Subject: Supplemental Information Regarding License Amendment Application to Increase
Spent Fuel Storage Capacity
(License Amendment Request No. 98-0013; TAC No. MB0688)

SUPPLEMENTAL INFORMATION
IN SUPPORT OF THE
APPLICATION FOR AMENDMENT
TO
FACILITY OPERATING LICENSE NPF-3
DAVIS-BESSE NUCLEAR POWER STATION
UNIT NUMBER 1

RESPONSE TO REQUEST FOR ADDITIONAL INFORMATION
REGARDING
LICENSE AMENDMENT REQUEST (LAR) 98-0013
FOR
DAVIS-BESSE NUCLEAR POWER STATION
UNIT NUMBER 1

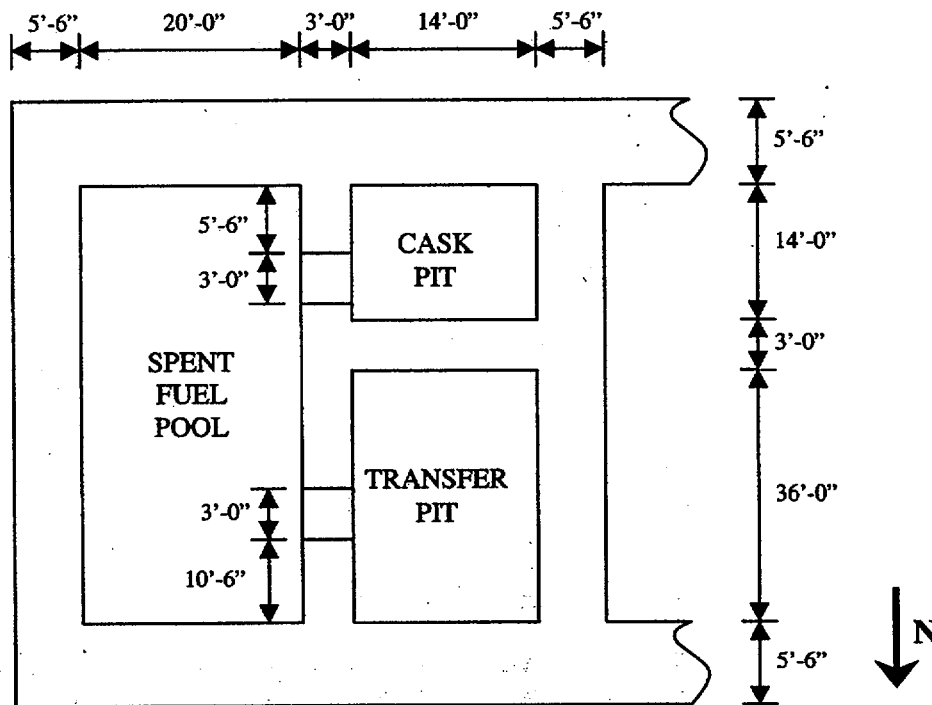
2. With respect to the calculations for determination of Spent Fuel Pool (SFP), Transfer Pit (TP) and Cask Pit (CP) capacities per SRP Section 3.8.4 and American Concrete Institute (ACI) 349, the following information is requested:

- a) Provide physical dimensions of the reinforced concrete SFP, TP and CP.
 - b) You indicated in Reference 1 that the calculated stresses in SFP, TP and CP will not exceed that of SRP Section 3.8.4 and ACI 349 which were used as guides. With respect to your stress calculations, discuss whether there are any changes in the factors of safety of the SFP, TP and CP when they are compared to the stress calculations reported in References 2 and 3. If there are any changes, provide the calculated factors of safety of the SFP, TP and CP in a tabular form for the axial, shear, bending and combined stress conditions.

- a) The nominal dimensions of the Spent Fuel Pool (SFP), Transfer Pit (TP), and Cask Pit (CP) are shown in Figures 8.2.1 through 8.2.5 of Holtec Design and Licensing Report HI-992329. A simplified plan sketch and a detailed description of the physical dimensions follows:

The SFP is 39'-6" deep, and measures 20'-0" x 53'-0" in plan. The operating deck is at elevation 603'-0" and the pool floor is at elevation 563'-6". The surrounding walls on three sides are 5'-6" thick. The fourth (western) wall separates the SFP from the TP and CP and is 3'-0" thick. The floor of the SFP is 5'-0" thick, with rooms located beneath that have walls that support the SFP floor.

The TP is 39'-6" deep, and measures 14'-0" x 36'-0" in plan. The TP floor is at elevation 563'-6". The north and west walls are 5'-6" thick. The south wall separates the TP from the CP and is 3'-0" thick. The east wall separates the TP from the SFP and is 3'-0" thick. The floor of the TP is 5'-0" thick, with a room located beneath it.

The CP is 46'-0" deep, and measures 14'-0" x 14'-0" in plan. The CP floor is at elevation 557'-0". The north, east, south and west walls are 3'-0", 3'-0", 5'-6", 5'-6" thick,

respectively. The CP floor consists of a 12'-0" thick reinforced concrete mass resting on the 3'-0" thick Auxiliary Building foundation mat.

There is a 3'-0" wide gate opening in the 3'-0" thick wall between the SFP and TP. The centerline of this gate is 12'-0" south of the SFP north wall. The gate extends from deck level (603'-0") down to the 578'-0" elevation.

There is also a 3'-0" wide gate opening in the 3'-0" thick wall between the SFP and CP. The centerline of this gate is 7'-0" north of the SFP south wall. The gate extends from deck level (603'-0") down to the 578'-0" elevation.
